## **Addendum # 1**

### **West Village Street Improvements Main Street from Great Jones Street to Duke Street City of Durham Project ST-235 January 7, 2009**

SHEET NO: LAYOUT PLAN  
**LA 1.1**

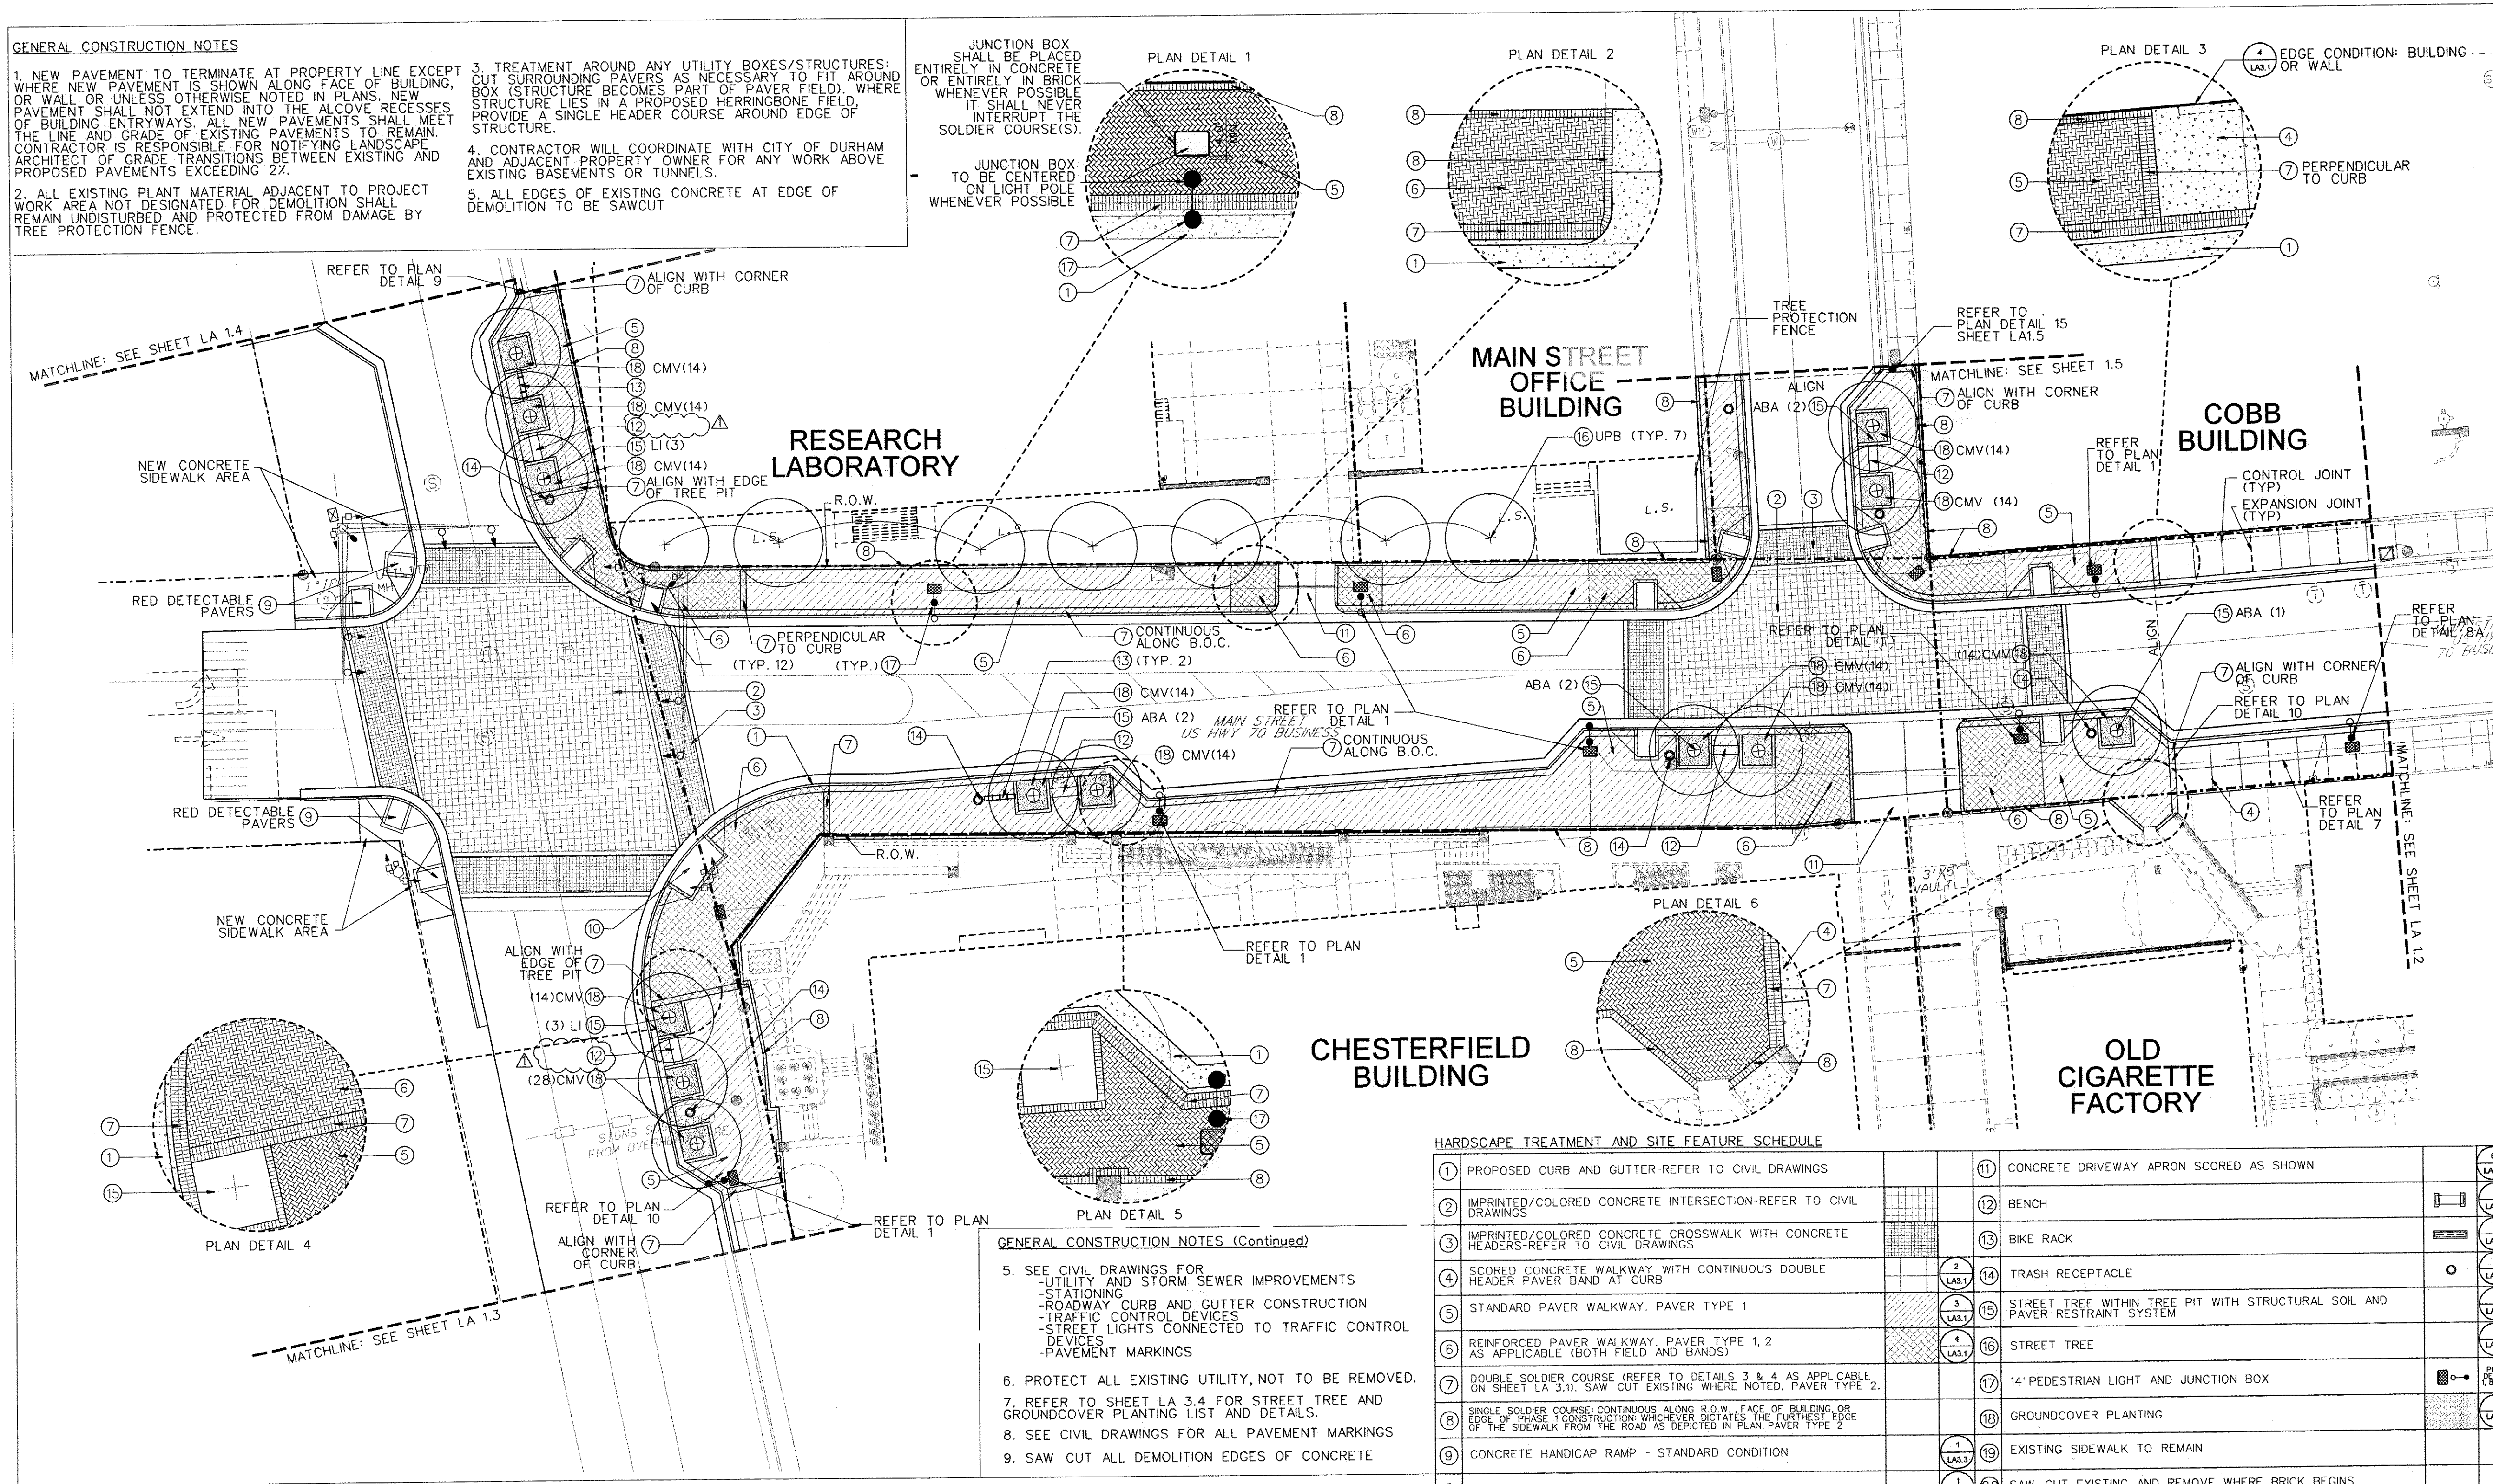
Plan sheet LA1.1 has been revised. The label (TYP. 2) was removed from the two benches along Duke Street. Items that were revised have been clouded and noted with revision 1. Plans sheet LA1.1 is attached to this email as well as posted on the City of Durham's project website. All trash cans and benches; labeled or unlabeled within the Limits of Contract are included in the project.

REVISIONS:	DATE:	BY:
Δ REMOVAL OF NOTE	1/5/09	MCC
